Re: State Center Fire Department  
Renovation & Addition – Redesign  
109 E Main Street  
State Center, Iowa 50247

## ADDENDUM #02

January 09, 2026

WOOD HEADER NOTES

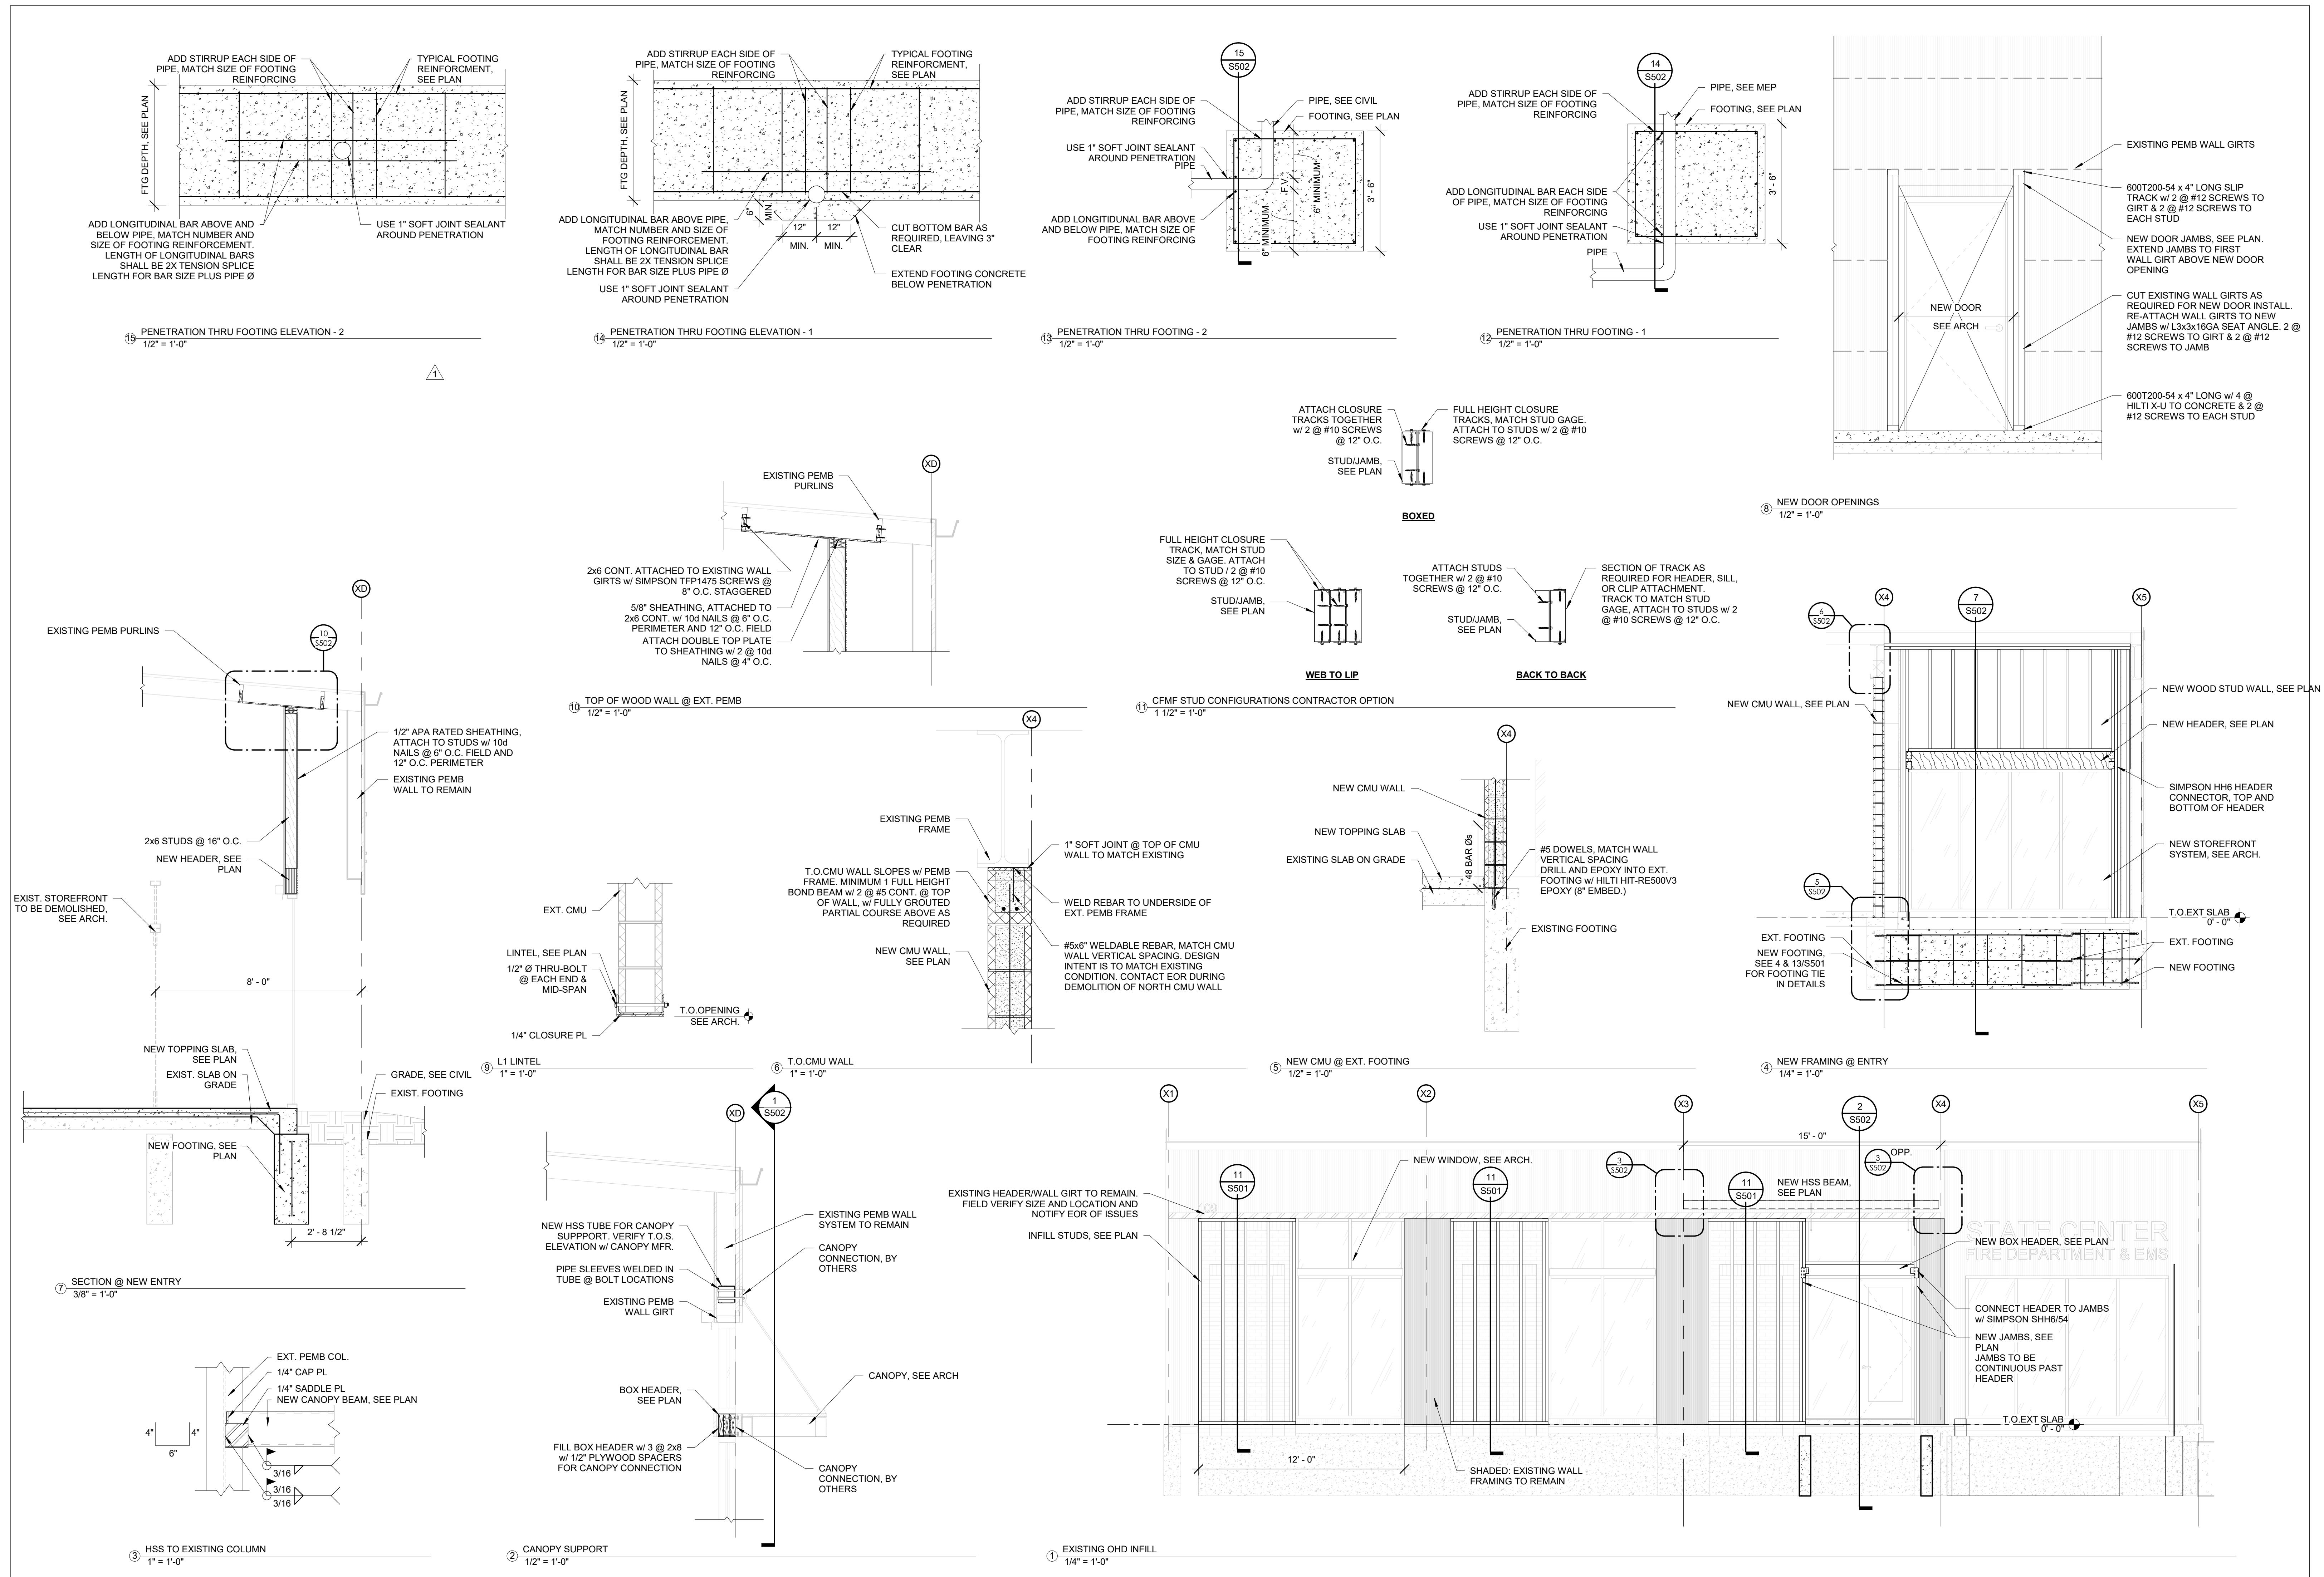
- Sheet S001
  - Revised Note S.2 in Concrete and Reinforcement General Notes to indicate drainage fill thickness under floor slab
- Sheet S101
  - No changes
- Sheet S102
  - No changes
- Sheet S201
  - Revised notes and shaded area to more accurately reflect approximate over-excavation locations
- Sheet S501
  - Revised Details 6, 7, & 8 to clarify trench footing construction if unsuitable soils are found. Option of extended footing or using lean concrete through unsuitable soils down to suitable soils are given. This is also found in the geotechnical report.
- Sheet S502
  - No changes

Sheet P6.1 – Plumbing Schedules... (24 x 36)

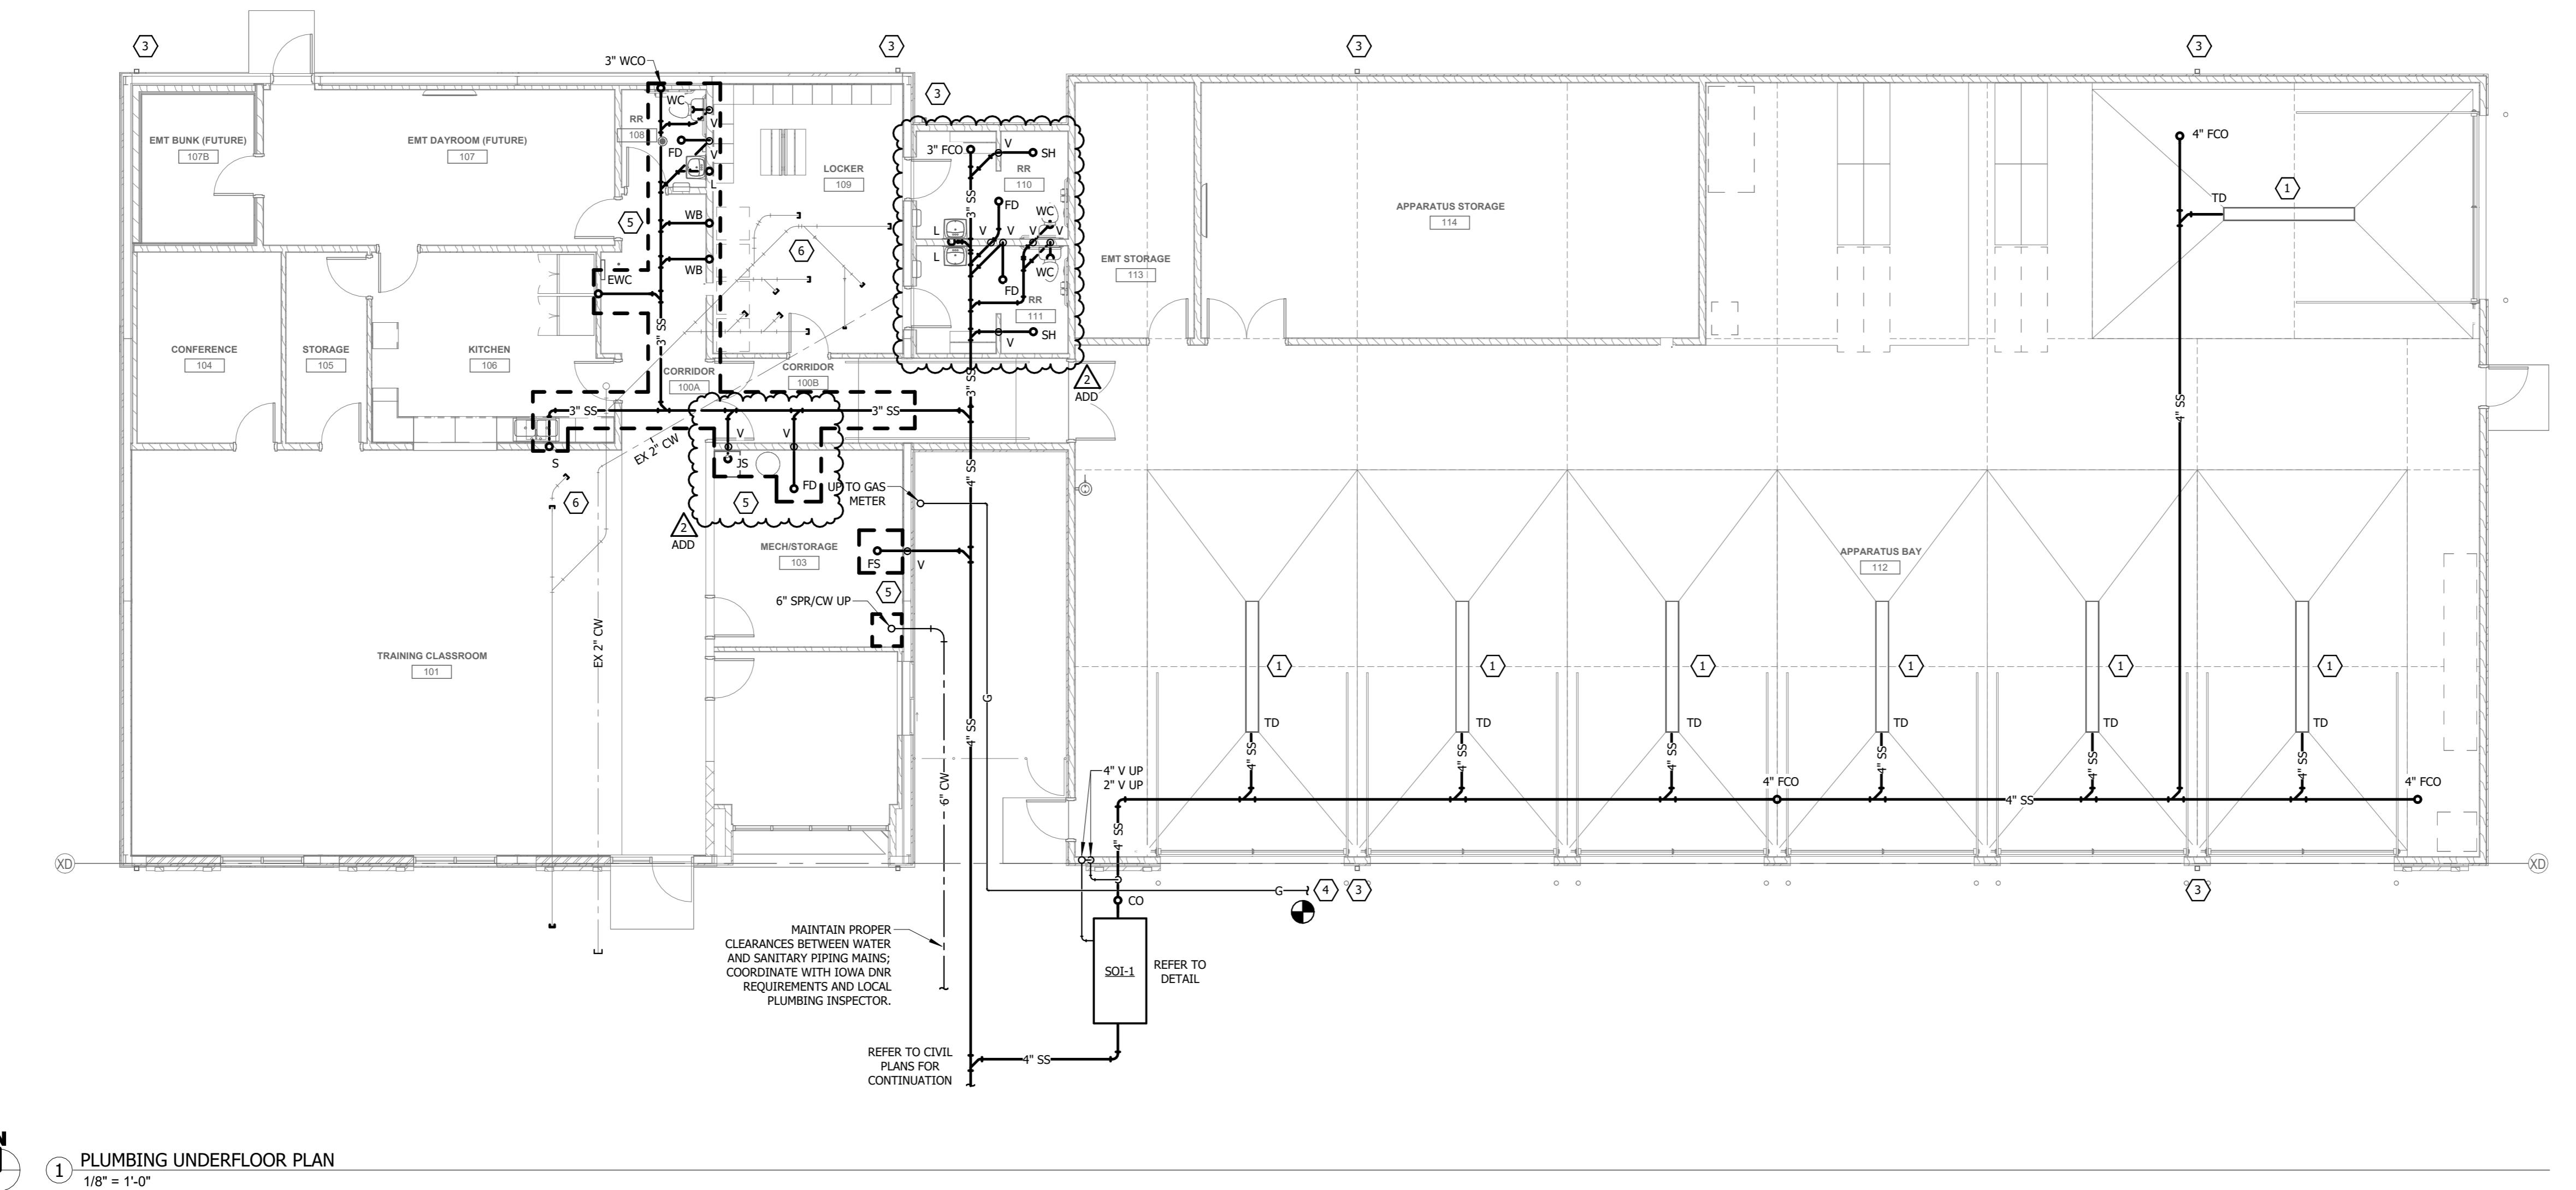
1. Plumbing Specialties Schedule
  - A. **ADD** Sand Oil Interceptor SOI-1 to be 500-gallon precast tank with traffic rated covers as described in schedule.

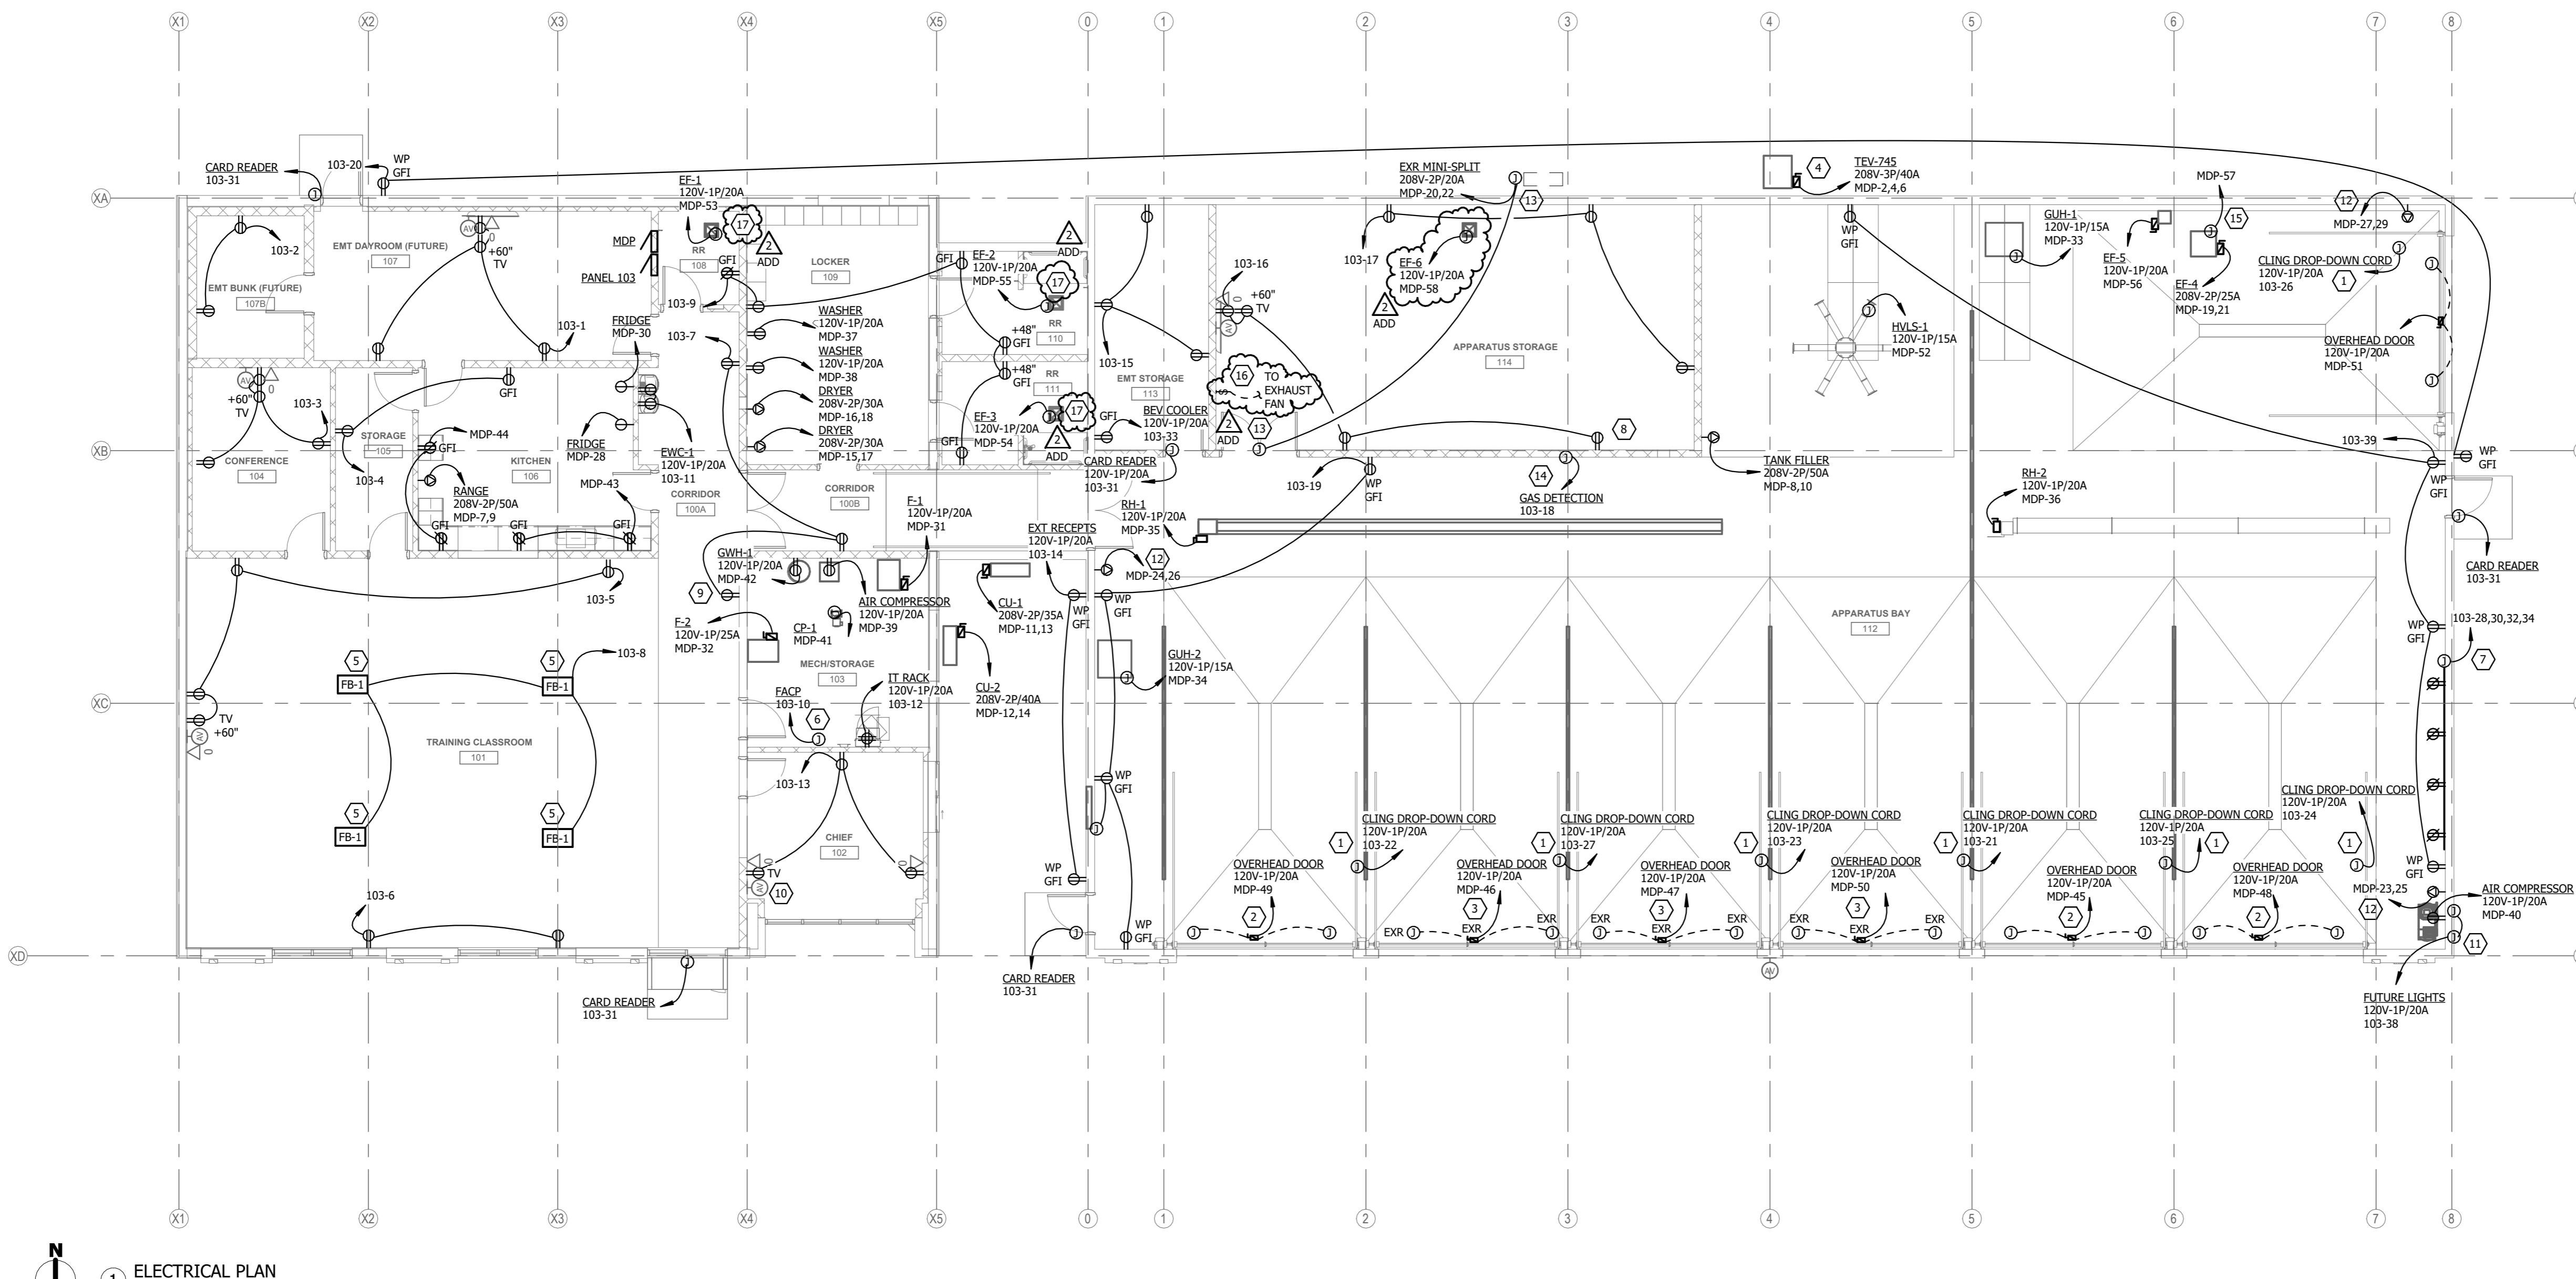
- 1. Exhaust Fan Schedule
  - A. **ADD** exhaust fan EF-6.
  - B. **REVISE** Note 2 to read, "EF-1, EF-2, EF-3, EF-6 shall operate with wall switch. refer to electrical plans."
